**GE Nuclear Energy**

ABWR

Subject ABWR ReviewMessage Info. pertaining to
RSW, MUWP, NECW, TCW and
TSW

Figure 9.2-6a TURBINE COOLING WATER SYSTEM DIAGRAM

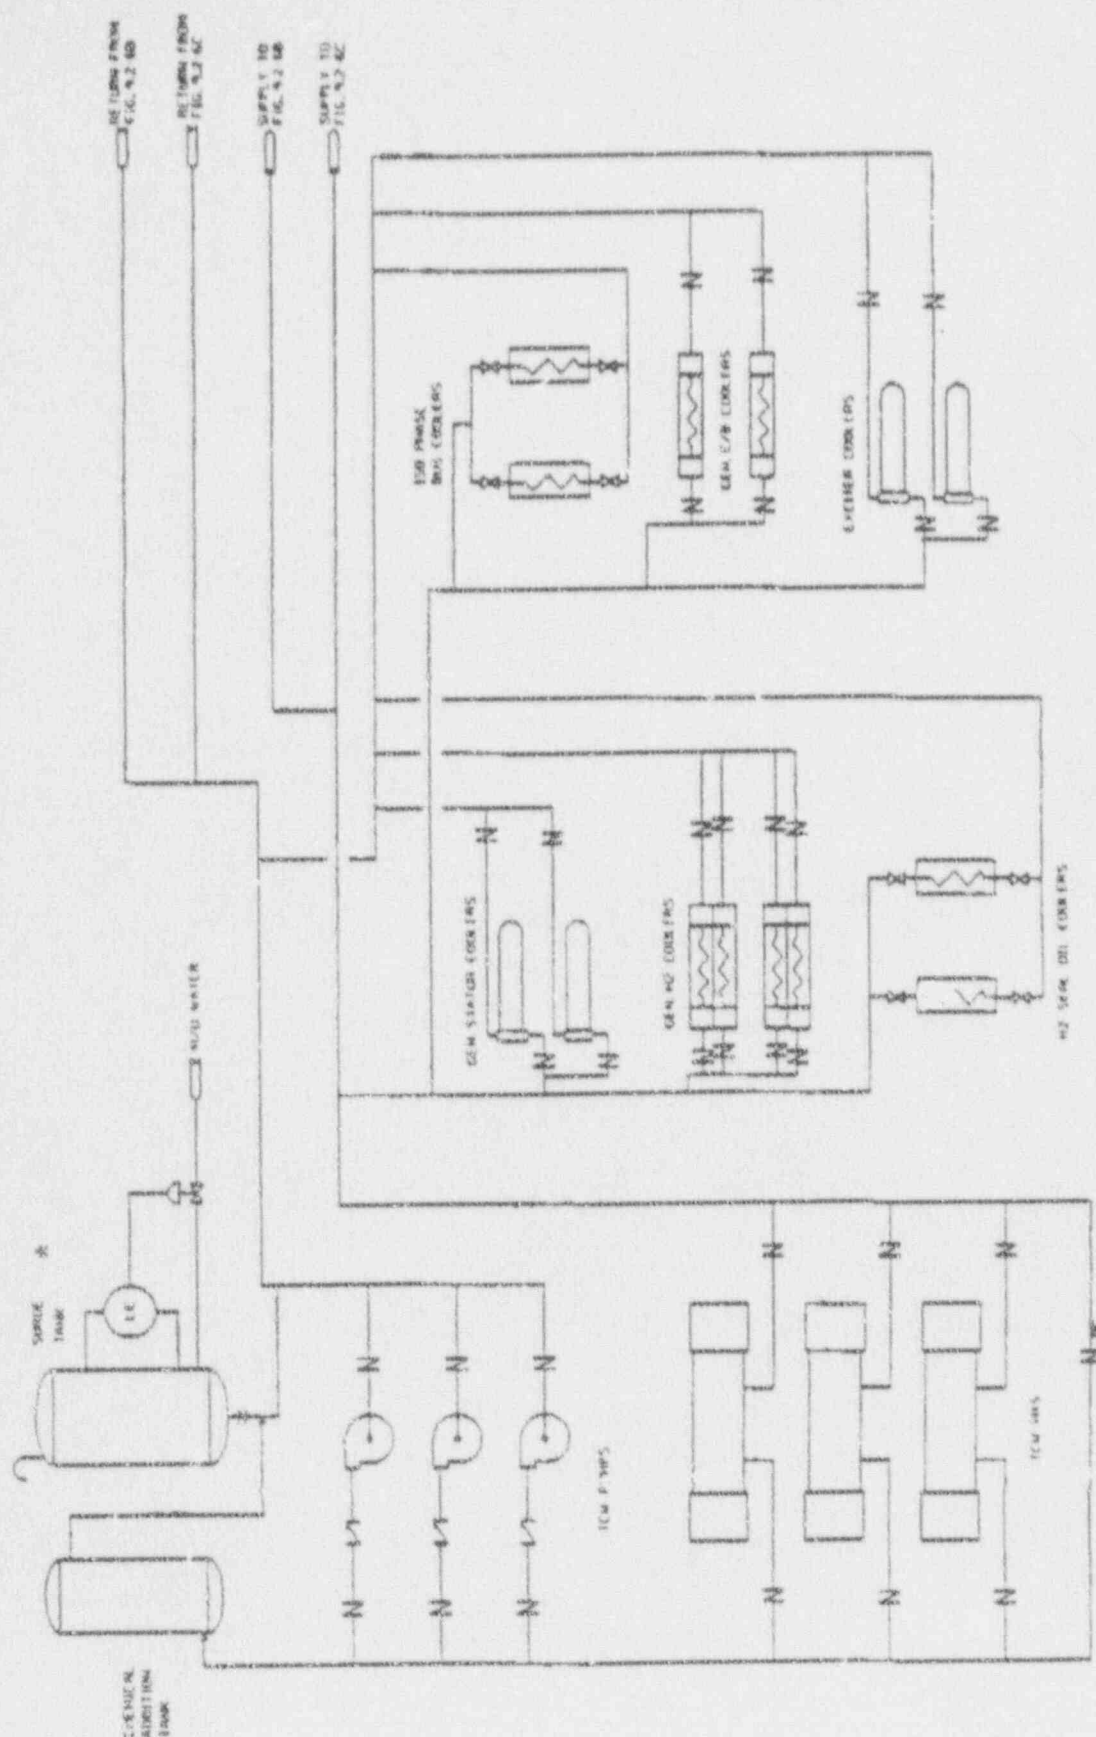
three pumps with a capacity of 15,000 gpm each,
three heat exchangers with heat removal capacity
of 65×10^6 Btu/h each,

During normal power operation, ^{two} ~~one~~ of the ~~maximum~~ capacity TCW system pumps circulate
